Kewaunee Nuclear Power Plant
Operated by Nuclear Management Company, LLC

NRC-05-081
10 CFR 50.55a

Inservice Inspection Third 10-Year Interval June 16, 1994 - June 16, 2004 Limitation
To Examination Relief Requests of the Kewaunee Nuclear Power Plant

**INSERVICE INSPECTION THIRD 10-YEAR INTERVAL
JUNE 16, 1994 - JUNE 16, 2004 LIMITATION TO EXAMINATION RELIEF
REQUESTS OF THE KEWAUNEE NUCLEAR POWER PLANT**

AHRS1-1A
RESIDUAL HEAT EXCHANGER

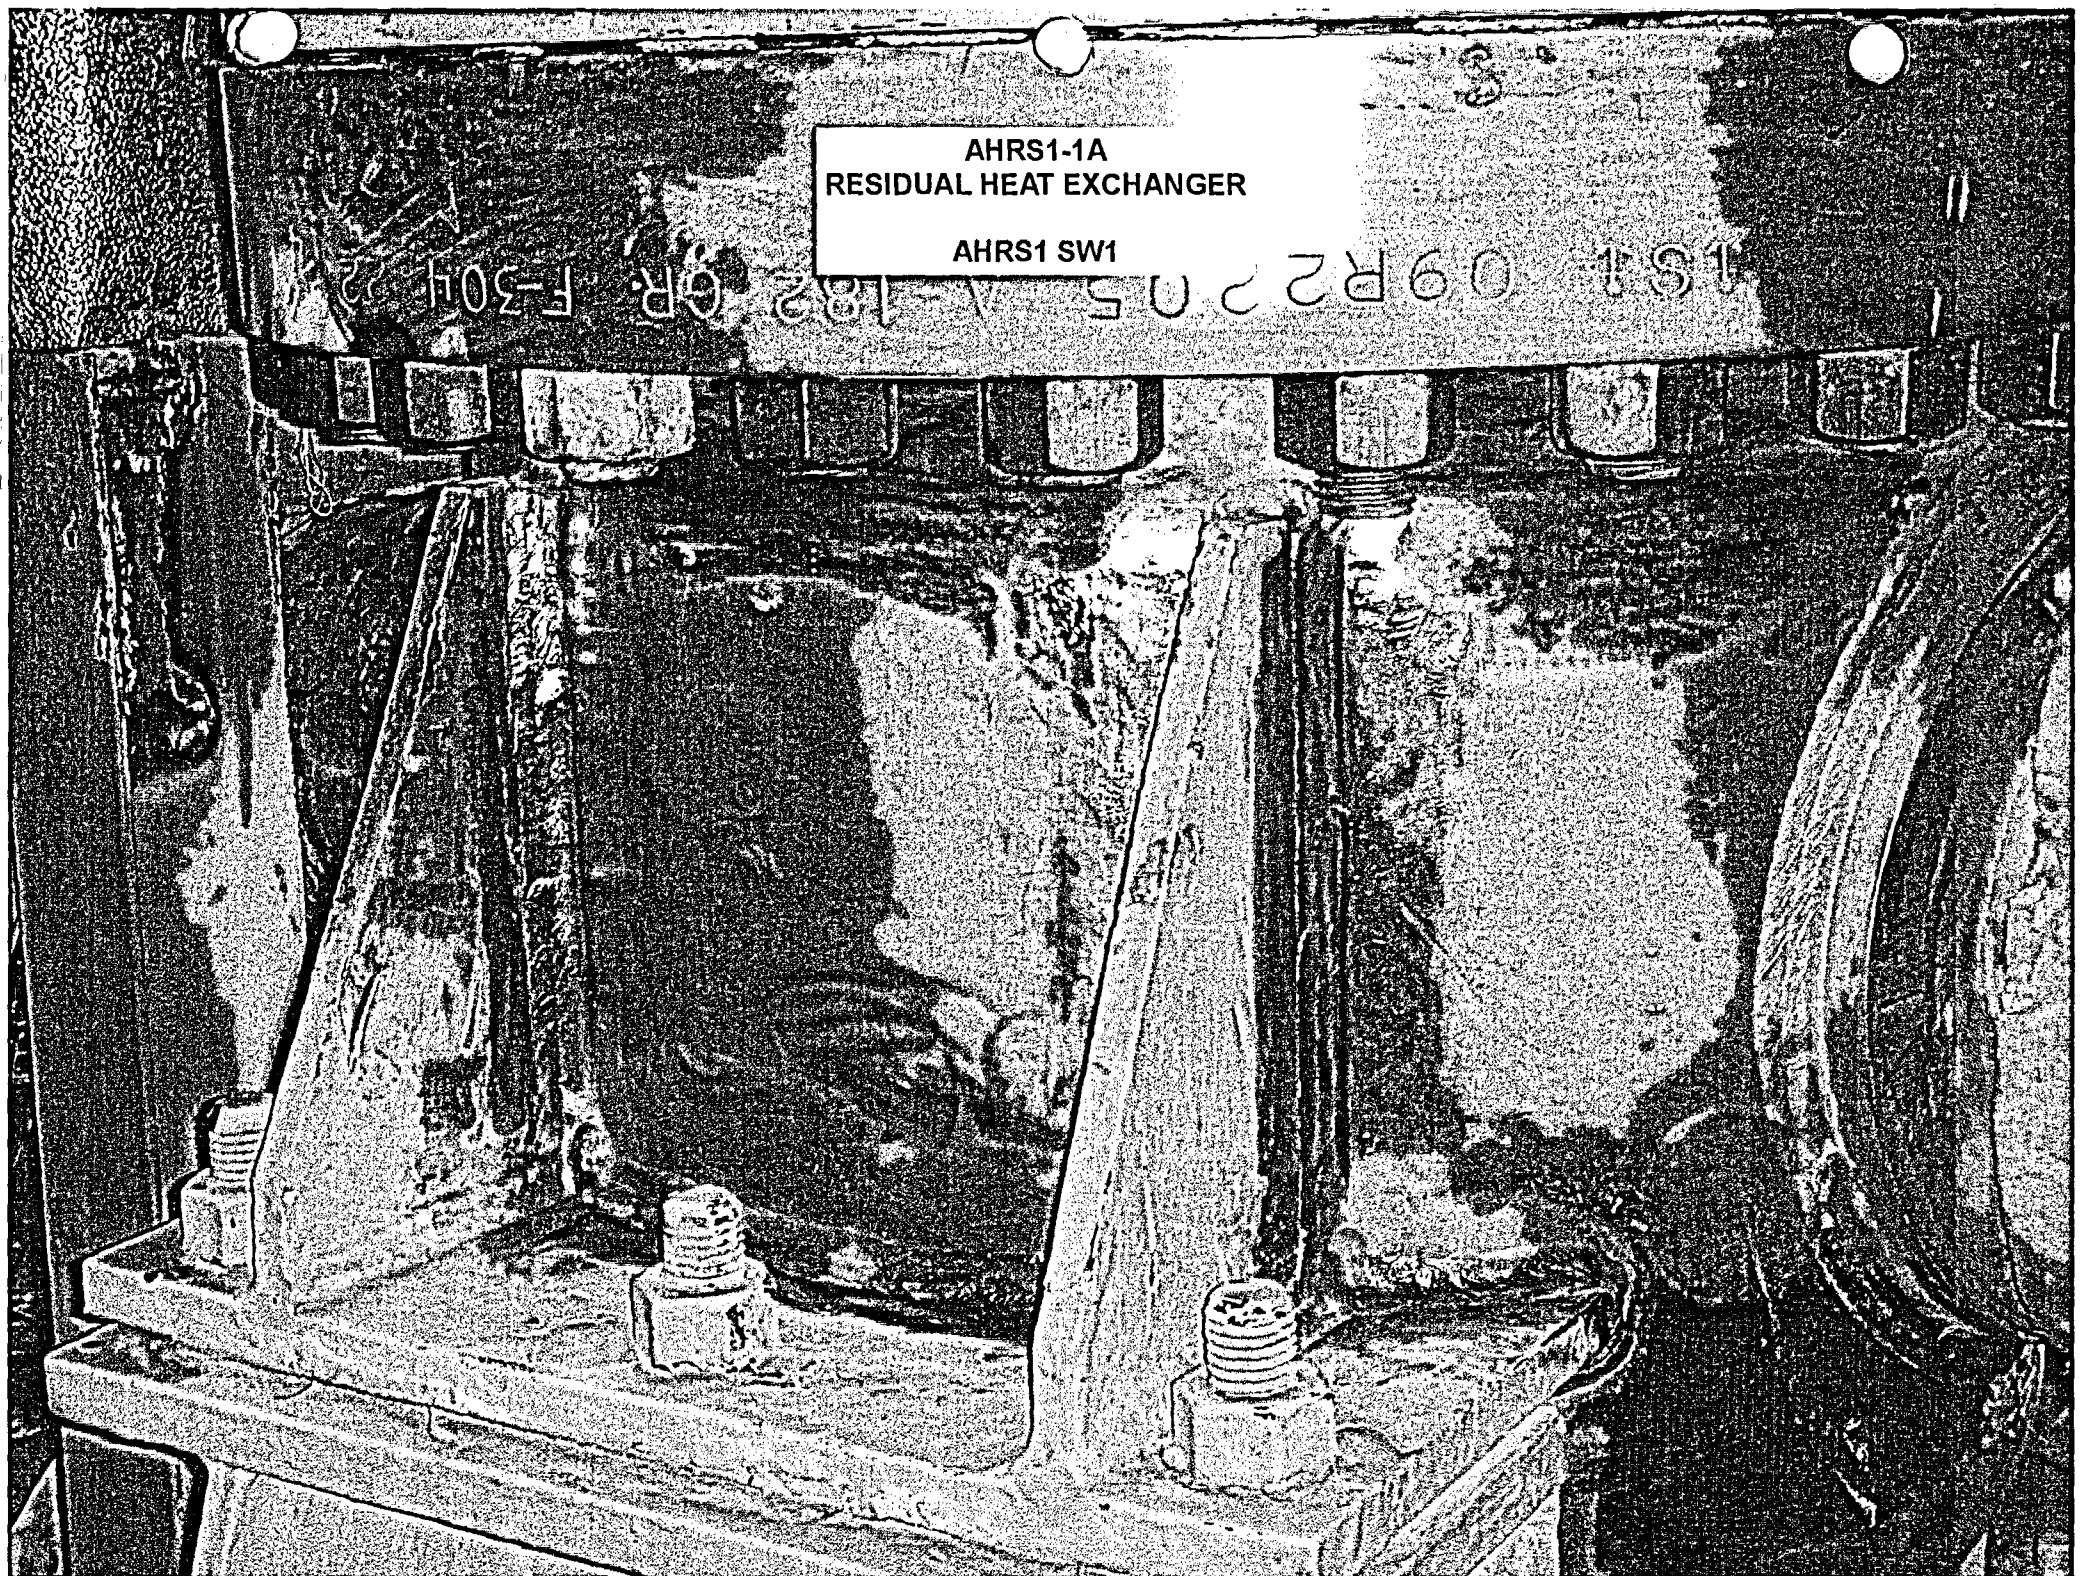
- 1. ASME Code Component Affected: Integrally Welded Attachment
AHRS1-SW1 and AHRS1-SW2
to Residual Heat Exchanger AHRS1-1A**
- 2. Applicable Code Edition and Addenda: 1989, No Addenda**
- 3. Applicable Code Requirement: Table IWC-2500-1; Examination Category
C-C; Item No. C3.10**
- 4. Impracticality of Compliance: 20.7% of the Integrally Welded Attachments
were inaccessible due to configuration of the Welded Attachment in close
proximity to the Residual Heat Exchanger thus restricting application of
the Surface Examination Liquid Penetrant.**
- 5. Burden Caused by Compliance: To provide for access to the 20.7% weld
area between the welded attachment and the Residual Heat Exchanger
would require modification from the Original Design of the Residual Heat
Exchanger and the Welded Attachment.**

AHRS1-W1
AHRS1-W2

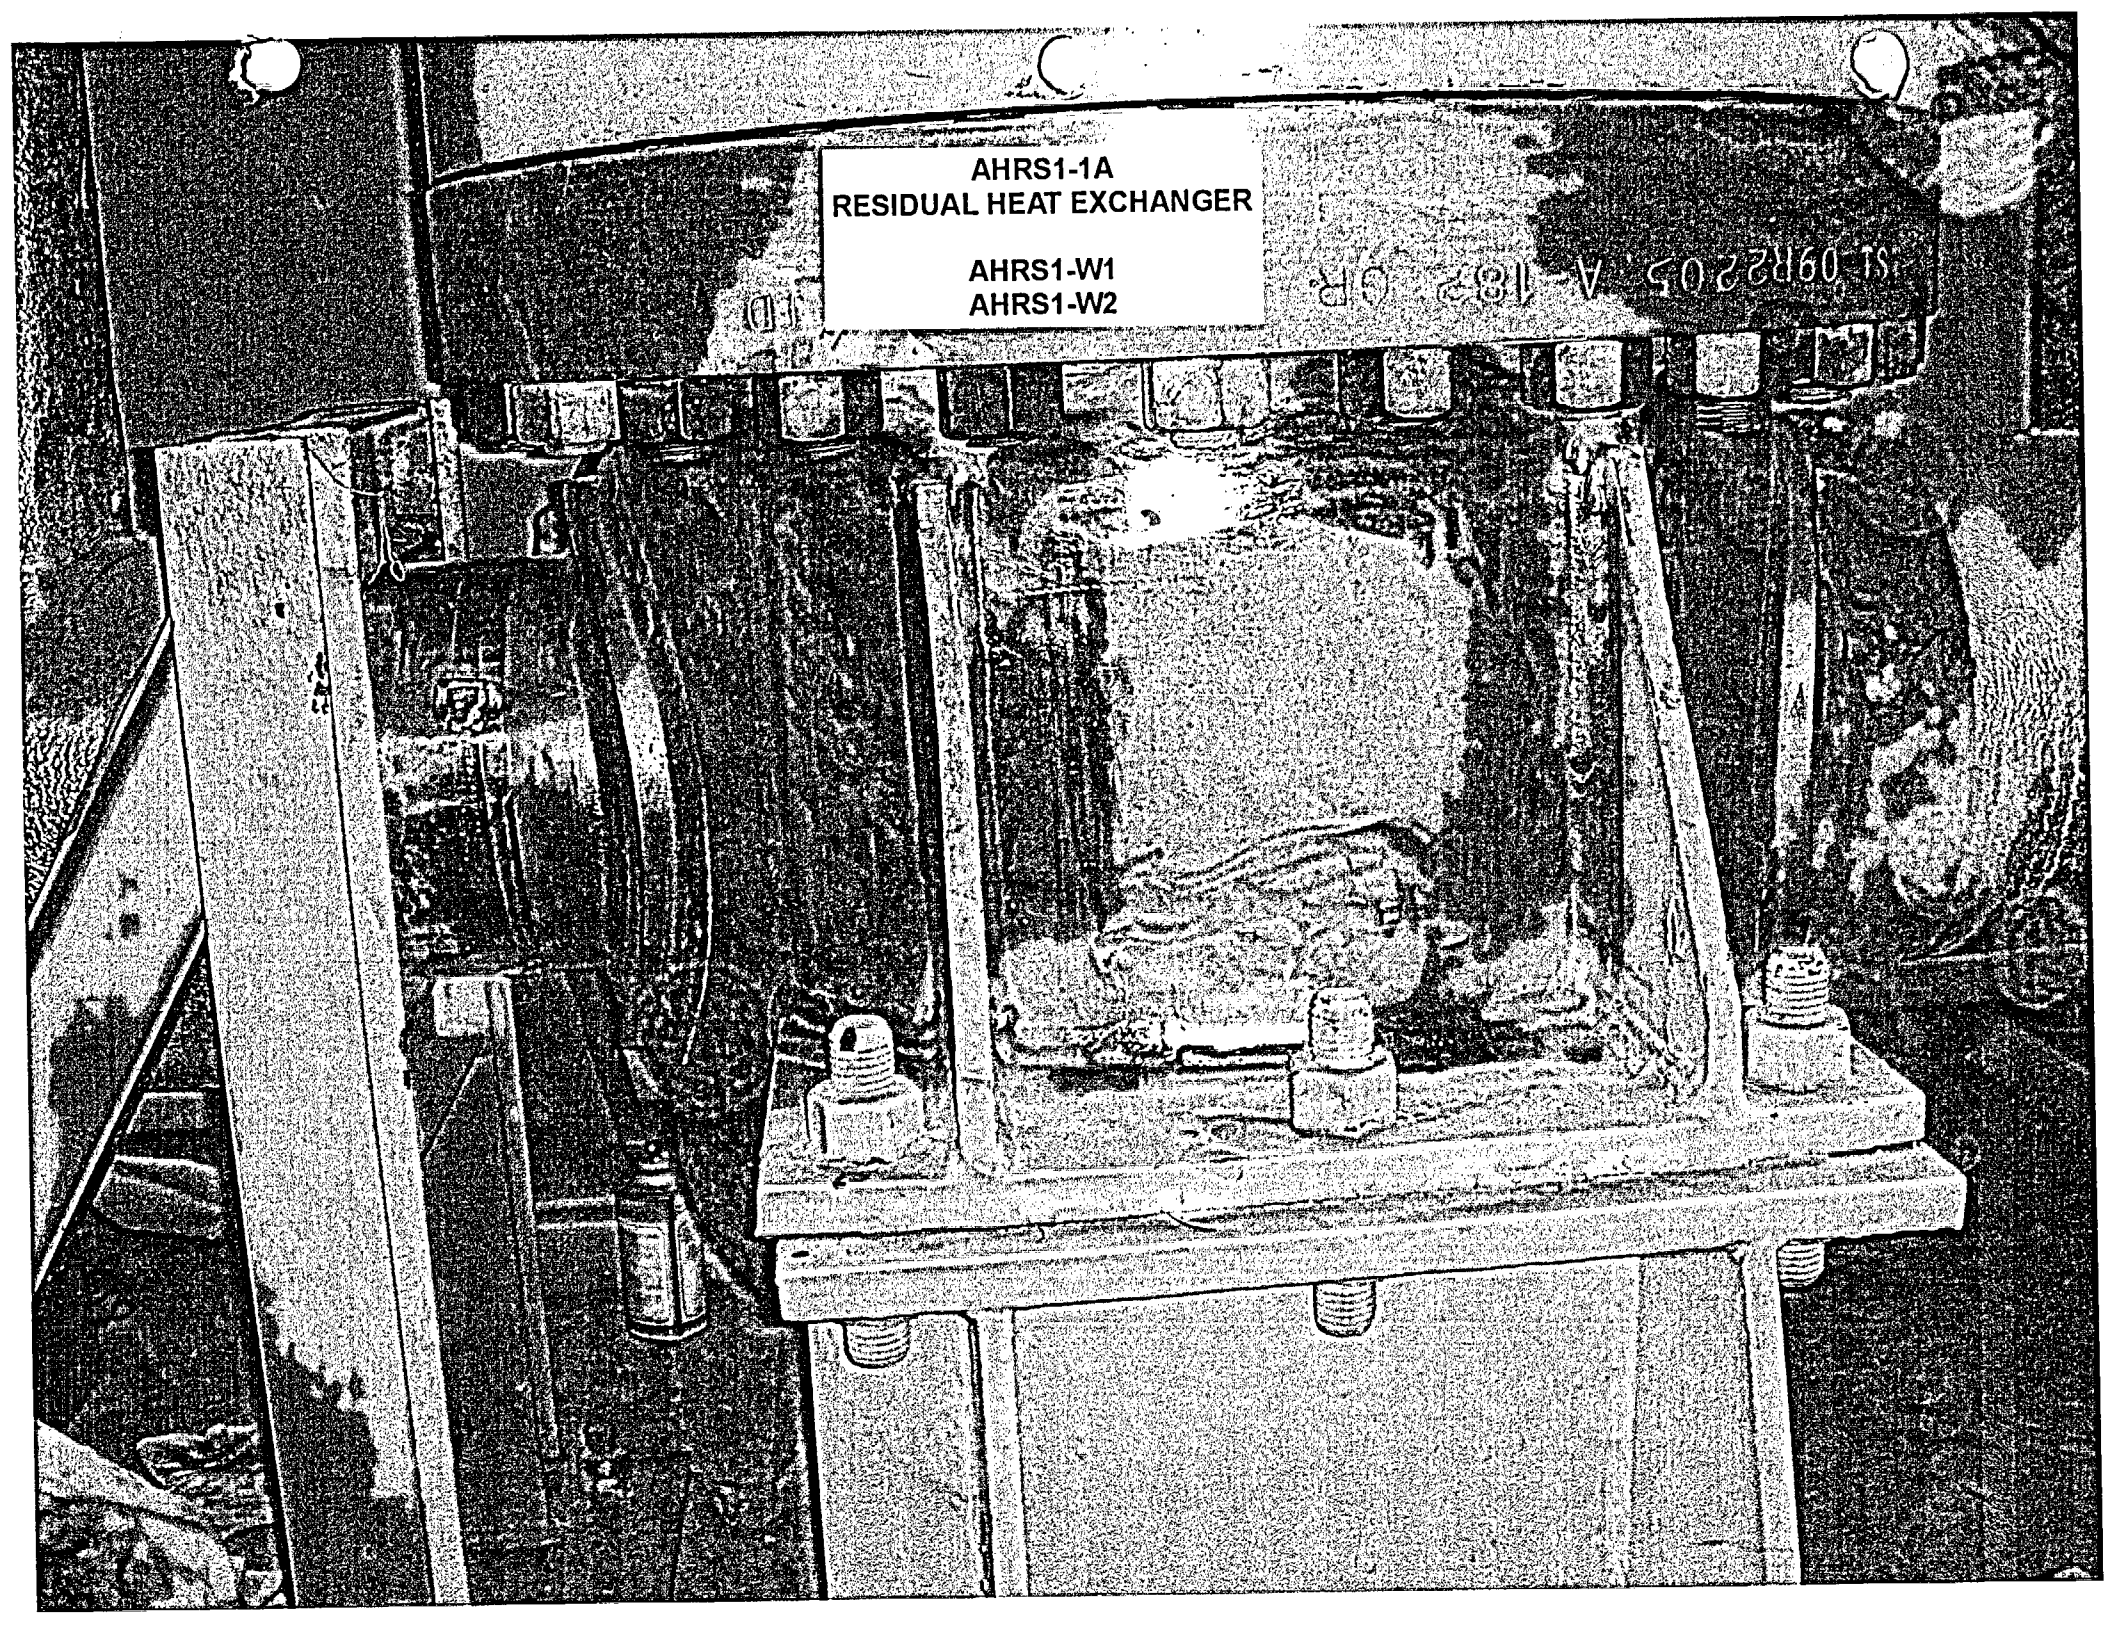
- 1. ASME Code Component Affected: Residual Heat Exchanger AHRS1-1A
Head Circumferential Weld AHRS1-W2**
- 2. Applicable Code Edition and Addenda: 1989, No Addenda**
- 3. Applicable Code Requirement: Table IWC-2500-1; Examination Category
C-A; Item No. C1.20**
- 4. Impracticality of Compliance: 37.6% of the Residual Heat Exchanger Head
Circumferential Weld AHRS1-W2 was inaccessible due to configuration of
the Residual Heat Exchanger Welded Support thus restricting Ultrasonic
Examination.**
- 5. Burden Caused by Compliance: To provide for access to the 37.6% of the
Head Circumferential Weld AHRS1-W2 would require modification from
the Original Design of the Residual Heat Exchanger.**
